Region 6 - Enforcement & Compliance Assurance Division

INSPECTION REPORT

Inspection Date(s):	02/07/2023 through 02/08/2023	
Media Program:	Drinking Water	
Regulatory Program(s)	Safe Drinking Water Act (SDWA) – Lead and Copper Rule (LCR)	
System Owner:	Sandia Public Works Department	
Operator Name:	Pueblo of Sandia	
System Name:	Sandia Resort and Casino Public Water System	
System Physical Location:	481 Sandia Loop	
(city, state, zip code)	Bernalillo, New Mexico 87004	
Mailing address:	Same as physical	
(city, state, zip code)	Same as physical	
County/Parish:	Bernalillo County	
System Phone Number	505-259-2332	
System Contact:	Michael Rivera	Lead Operator/Lab Technician
	mriviera@sandiapueblo.nsn.us	
System Classification:	NTNC	
PWS ID:	63506114	
Personnel participating in inspection:		
Sami Doupnik	EPA Region 6	Enforcement Officer
Jessica Moore	EPA Region 6	Enforcement Officer
Craig Young	EPA Region 6	Enforcement Officer
Danny O'Connell	PG Environmental (EPA Contractor)	Inspector

Photograph 5. Pressure Gauge, W0001 Line View of a pressure gauge on the W0001 line that read approximately 160 psi on February 7, 2023, the first day of the inspection.

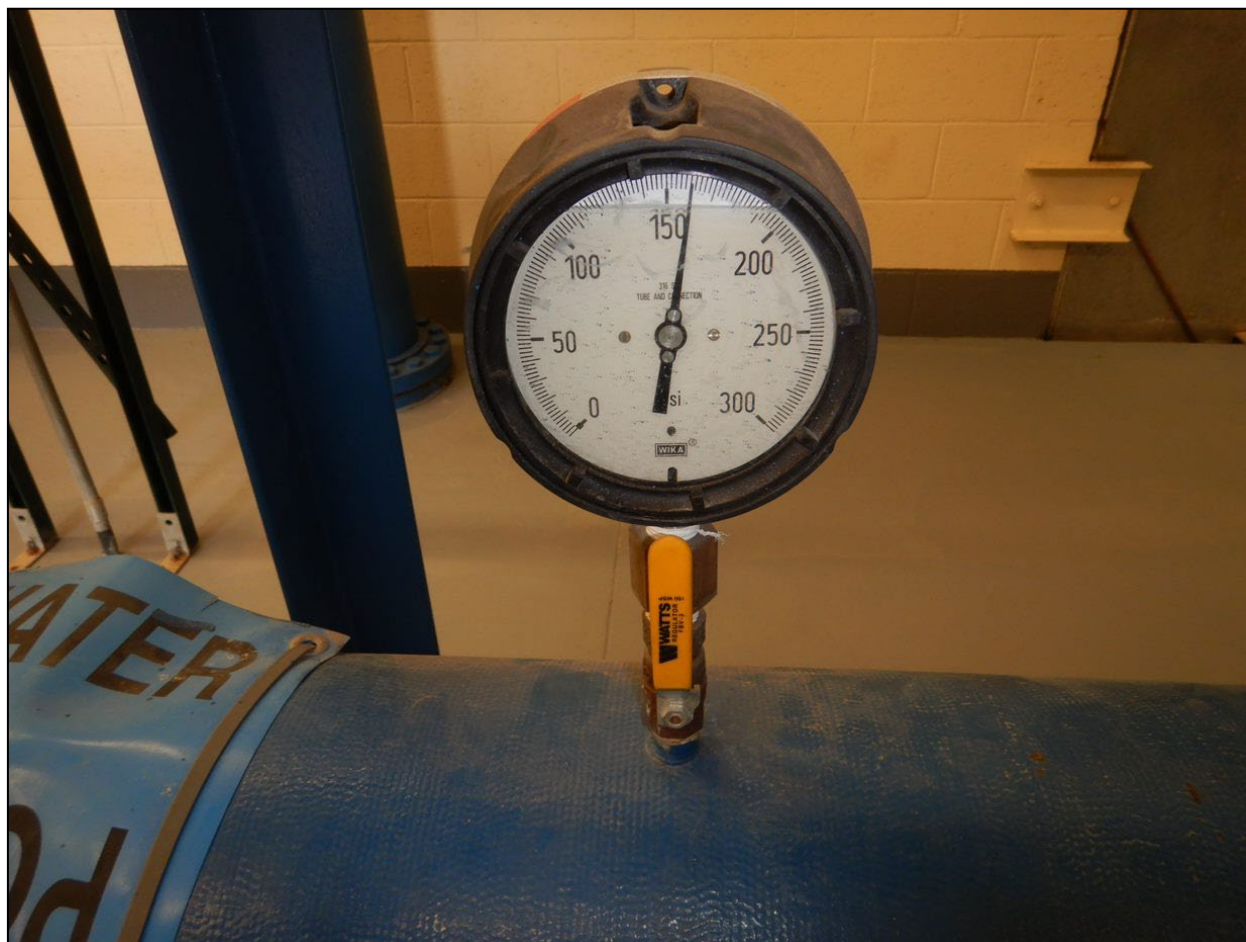
Casino Well No. 1 has an intake that is 480-1160 feet deep, and the soft start pump in the well building has a 1100 GPM capacity. The pump is lubricated using food-grade machinery mineral oil (Clarion A/W 32 Machinery Oil), and the EPA Inspection Team observed the lube line connection to the mechanical seal of the pump (refer to [Appendix 1, Photograph 2](#)). An air relief valve drain line along the pump line was not screened (refer to [Appendix 1, Photographs 3 and 4](#)). When operators became aware of this, a screen was placed on the valve drain line. The pump was not on at the time of the inspection, and the pressure gauges in the line downstream of the check valve read approximately 160 psi (refer to [Appendix 1, Photograph 5](#)).

Photograph 15. W0002 Air Relief Valve View of a screened air relief valve on the W0002 pump raw water line.

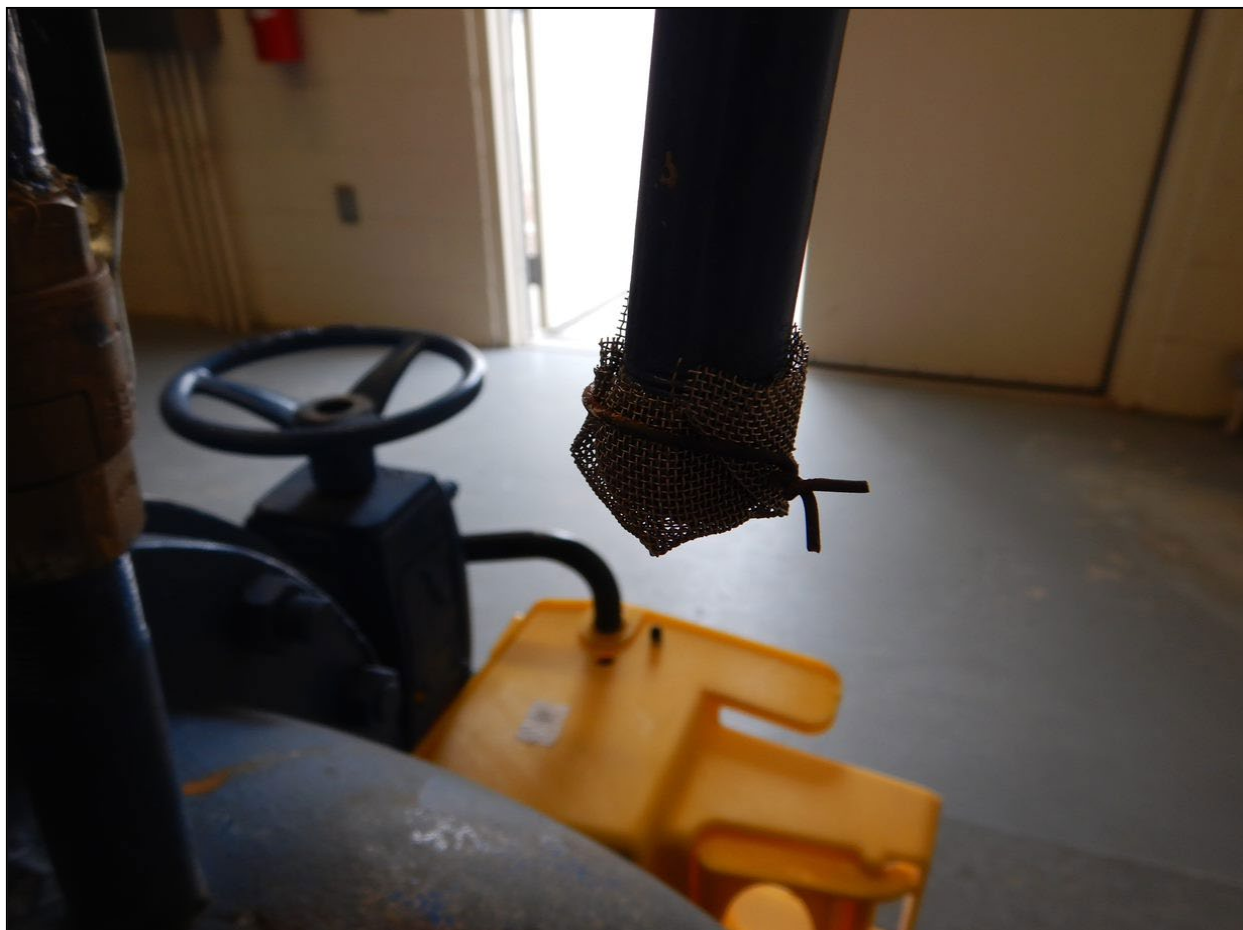
Casino Well No. 2 has an intake that is 480-1160 feet deep, and the soft start pump in the well building has a 980 GPM capacity. The pump is lubricated using food-grade machinery mineral oil. The W0002 well is set up similarly to W0001, with a pump, raw water line, and a pump-to-waste line with a PRV (refer to [Appendix 1, Photographs 12 and 13](#)). Air relief valve drain lines at W0002 were screened with mesh (refer to [Appendix 1, Photographs 14 and 15](#)).

Photograph 29. Ferric Chloride Barrel, Ferric Chloride Storage/Pump Room View of one of the empty 38% ferric chloride barrels in the ferric chloride room. The barrel was sitting on secondary containment. There was some brown staining on the containment around the barrels.

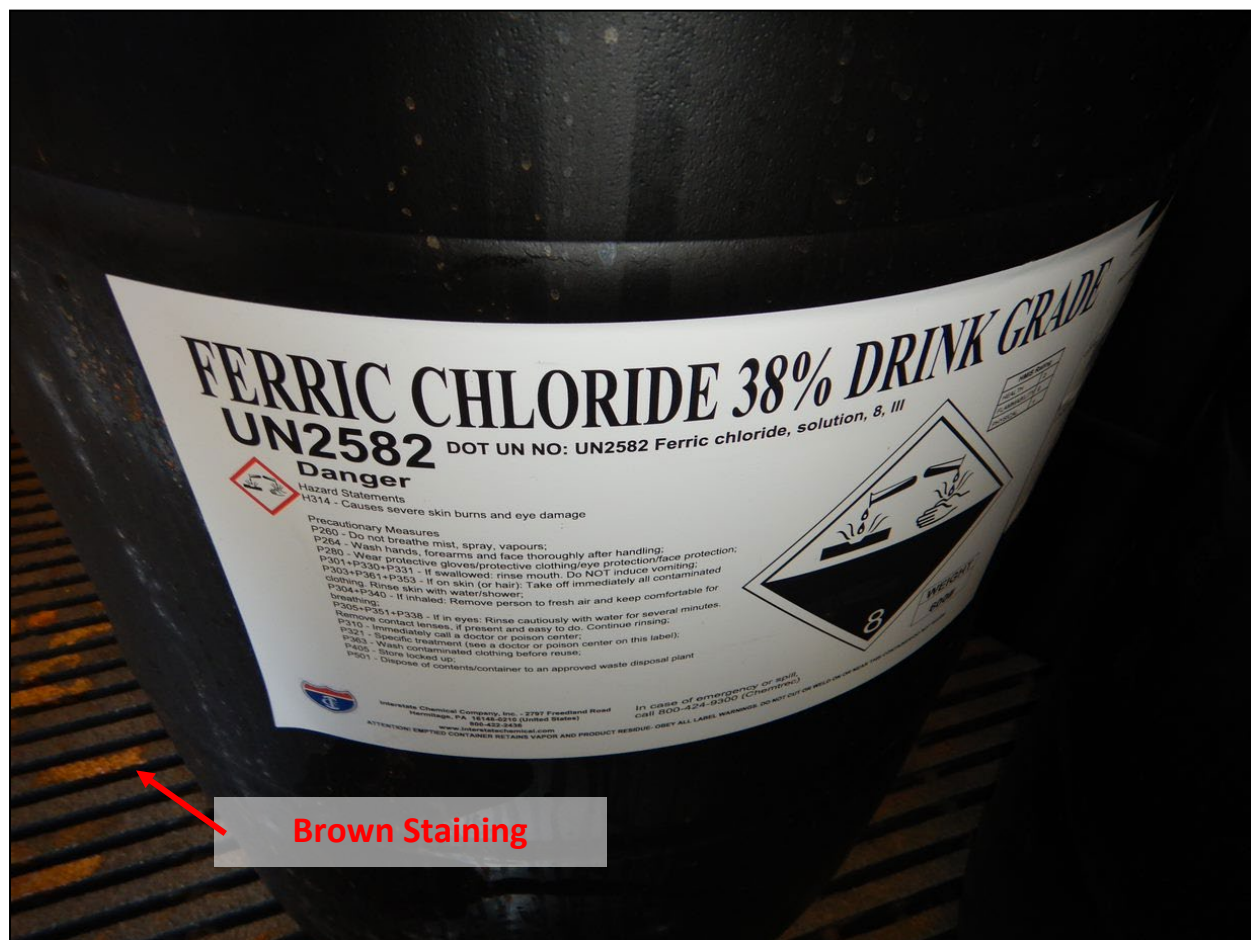
The ferric chloride storage and pump room was located in a building immediately to the west of the treatment building and north of the filter pad. The room contained several empty ferric chloride barrels, along with a semi-full tote. The barrels and tote were positioned over secondary containment (refer to [Appendix 1, Photograph 29](#)). There was some brown staining on the secondary containment around the barrels. Two ferric chloride pumps were also present in this room, with one pump being a lead and the other a lag. The pumps were placed on a pump skid over secondary containment, and there were brown stains on the wall and skid, indicating past spills or leaks (refer to [Appendix 1, Photograph 30](#)). Operators said that the pumps were rotated regularly. Ferric chloride is used to facilitate arsenic precipitation so that it can be filtered out by the Tonka anthracite filters. A hose bib present in this room contained a vacuum break for backflow prevention. The metal on the hose bib showed discoloration (refer to [Appendix 1, Photograph 31](#)).

Photograph 38. Food Grade Lubricant, Treatment Room View of the Clarion food grade machinery lubricant that was being stored in the treatment room.

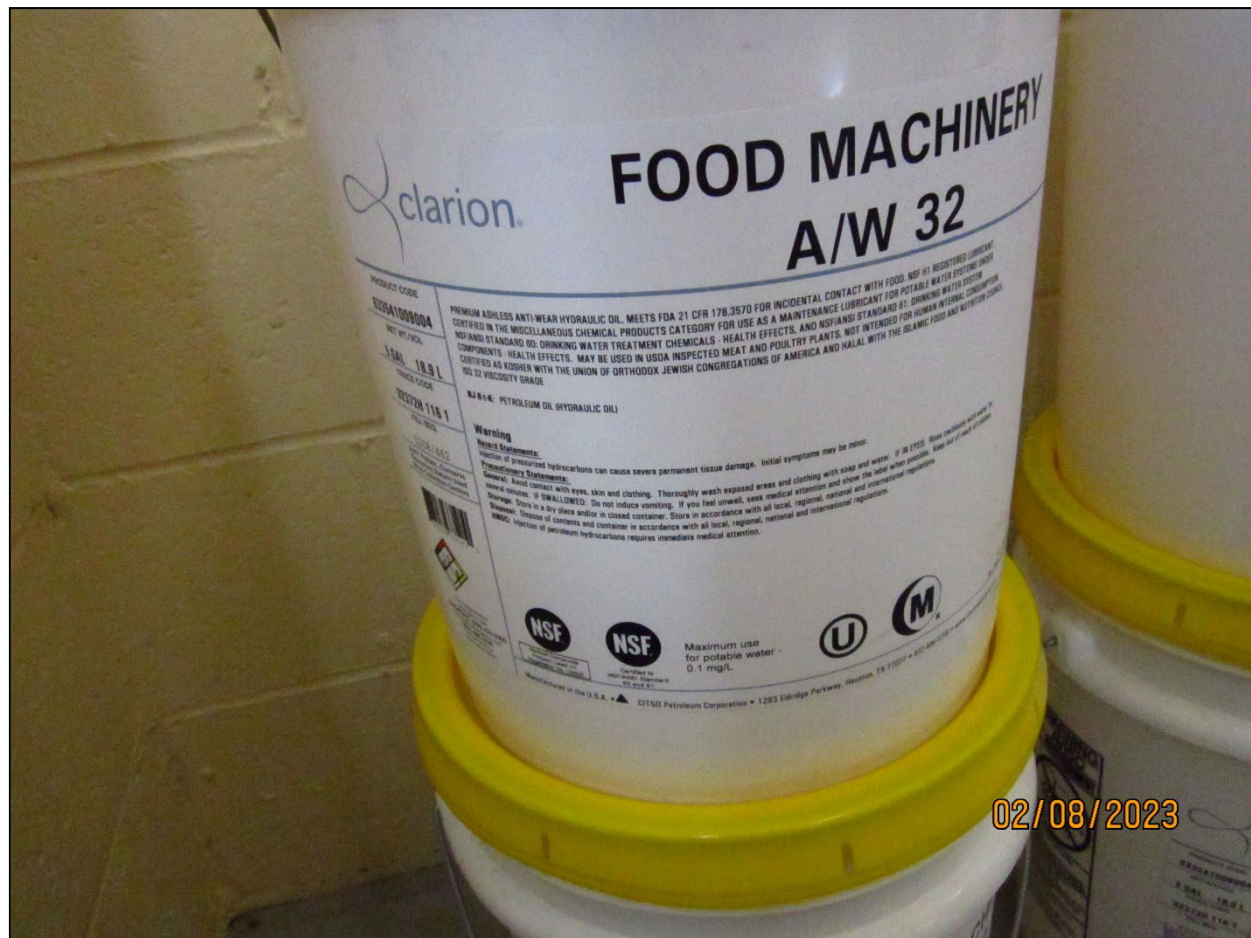
The EPA Inspection Team observed the water treatment room and its various components (refer to [Appendix 1, Photograph 37](#)). Food grade lubricant was being stored in this room (refer to [Appendix 1, Photographs 38 and 39](#)). The treatment system was not in operation during the inspection due to a valve actuator failure on the filter discharge main line prior to final chemical injection (refer to [Appendix 1, Photograph 40 and 41](#)). The valve was referred to as the “effluent valve.” Operators stated that early Sunday morning, prior to the inspection (February 5, 2023), at approximately 5:00 a.m., the SCADA system alerted operators of the failed valve.

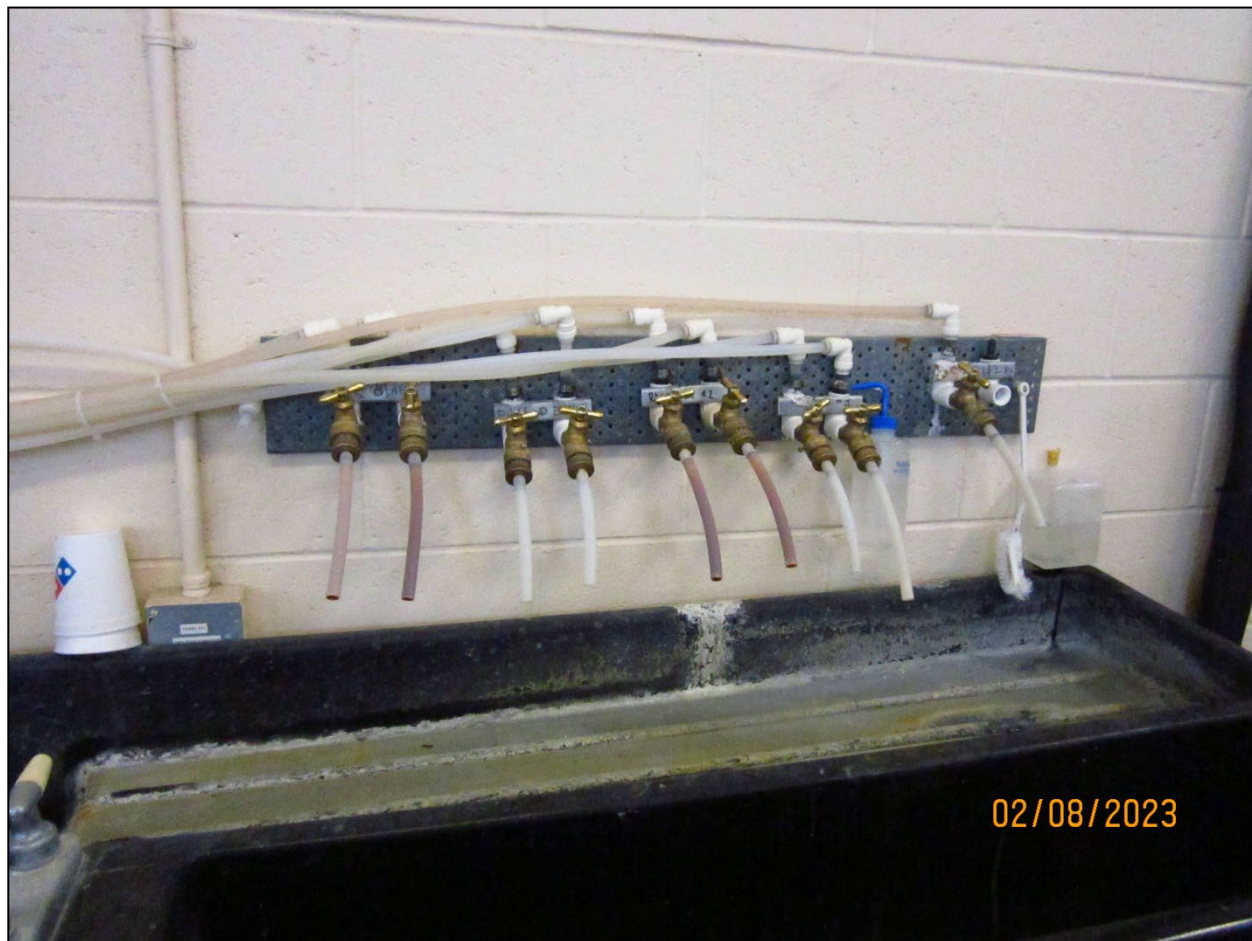
A sampling sink was present next to the treatment infrastructure, and there were several sample lines taken from various points in the treatment process (refer to [Appendix 1, Photograph 52](#)). These points include raw influent, water post filtration from Filter Nos. 1 and 2, and final treated effluent. The interior of the tubing from the samples for Filter Nos. 1 and 2 was stained red-brown due to the addition of ferric chloride (refer to [Appendix 1, Photograph 53](#)).
